Before the Independent Hearing Panel  
Appointed by the Timaru District Council

**Andrew Willis - Final Reply**

**Strategic Directions, Contaminated Land, Hazardous Substances,  
Stormwater, Energy and Infrastructure, Transport, Drinking Water  
Protection, Natural Hazards, Coastal Environment**

# Overland Flowpath Assessment Area & Revised Flood Assessment Area Map "Geraldine Area"

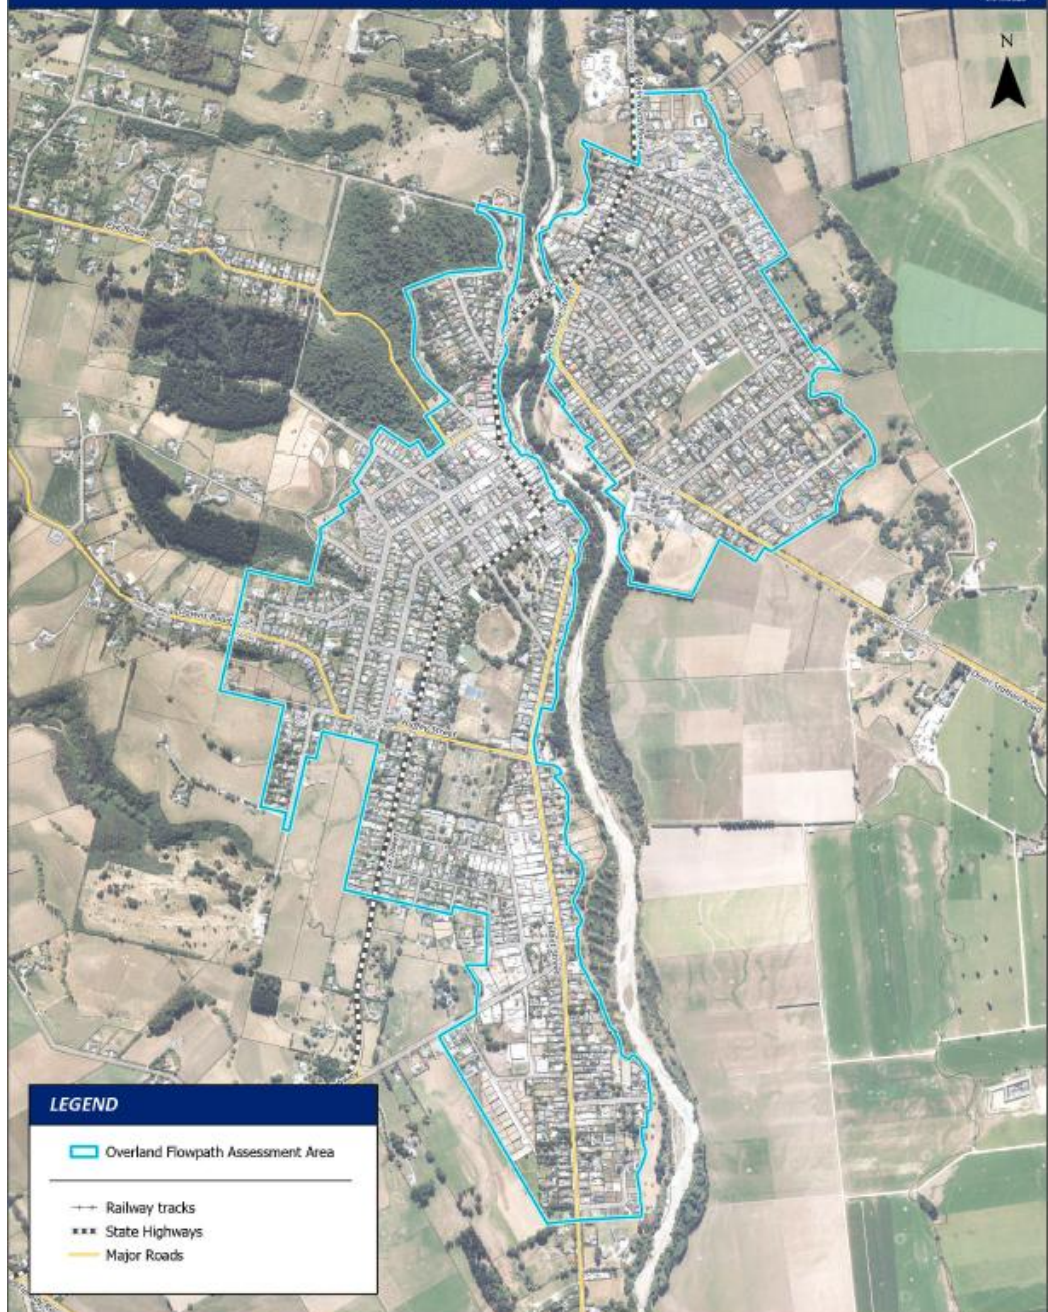
- reinstating the notified permitted activity standard (PER-2) in NH-R1 that requires a Flood Assessment Certificate to confirm a site is not located within an overland flowpath, but narrowing the application of this notified standard by limiting it to existing Council stormwater management areas in Timaru, Temuka, Geraldine and Pleasant Point, identified via an additional overlay in the PDP (i.e. the Overland Flowpath Assessment Area Overlay);

- inserting the Overland Flowpath Assessment Area overlays into the planning maps (see **Appendix B** for these).
  - a minor change to NH-S1 to account for these changes (by adding a reference to the Overland Flowpath Assessment Area Overlay in NH-S1(1)(c));
